Title: 6 Rel-4/5/6 CR 32.602/12/62 (Basic/ Bulk/ Kernel CM IRP IS):

Correction of System Context

Document for: Decision

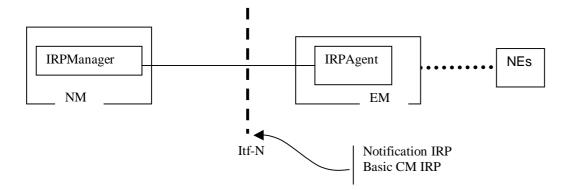
Summary of change	e: 器 Cor	rection of the to	ext in subclaus	se 4.1			
Consequences if not approved:	₩ The	specification v	vould contain	errors and	l ambiguities.		
Clauses affected:							
Other specs affected:	X X	Other core s Test specific	ations	æ			
Other comments:

The IRPAgent implements and supports this IRP. The IRPAgent can reside in an Element Manager (EM) or a Network Element (NE) (see also [2] clause 8). In the former case, the interfaces (represented by a thick dotted line) between the EM and the NEs is not the subject of this IRP.

An NE can be managed via System Context A or B. The criterion for choosing System Context A or B to manage a particular NE is implementation dependent. An IRPAgent shall support one of the two System Contexts. By observing the interaction across the Itf-N, an IRPManager cannot deduce if the IRPAgent supports System Context A or B. An IRPManager using this IRP shall choose one of the two System Contexts defined here, for each NE. For instance, if an EM is responsible for managing a number of NEs, the NM shall access this IRP through the EM and not directly to those NEs. For another IRP though, the System Context may be different.
